M1 to Raymond Terrace Project Manager,
Locked Bag 2030
NEWCASTLE
NSW 2300

Re: M1 Extension to Raymond Terrace

Figure 1: Heatherbrae Project Area in red (P.9 Contextual analysis)

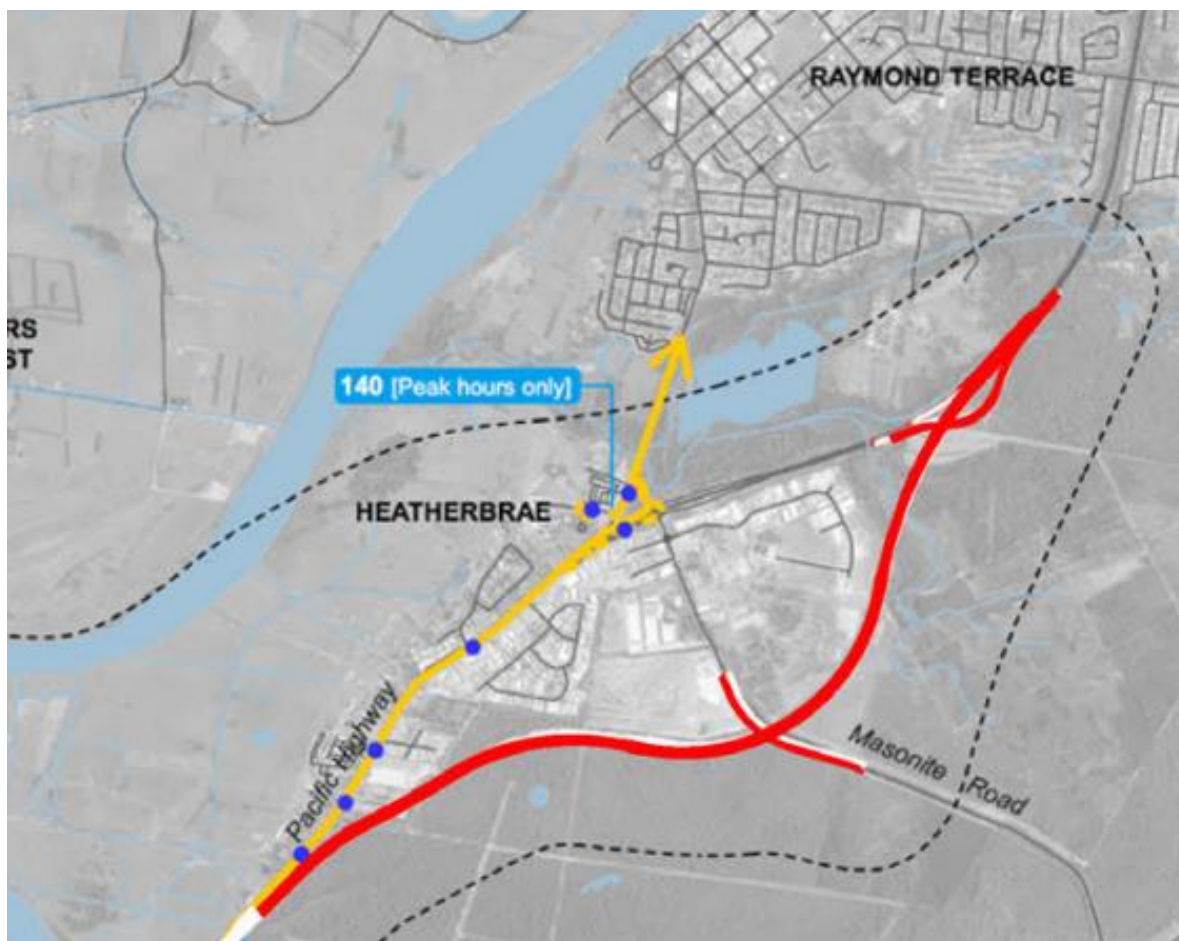
Bicycle NSW is concerned that active travel is not considered in the Heatherbrae project.

Question: How does the Heatherbrae bypass meet design Objective 4, Part 3 of ‘connectivity for all road users including cyclists and pedestrians’ when it states in Design Elements (p.23) that ‘there are no areas where pedestrians and cyclists can access the Motorway’?

Clearly, motorways are constructed as movement corridors exclusively for vehicles, not pedestrians and cyclists. But the UDLP is also governed by place-making objectives which extend beyond aesthetics and include impacts to communities. Given that cyclists and pedestrians exist, and Heatherbrae is an urban rural place with a variety of uses, what provision is made for permeability of active travel in and through this corridor?

Therefore, how might the project attempt to upgrade the existing highway to meet Objective 4 and make it more amenable for AT?
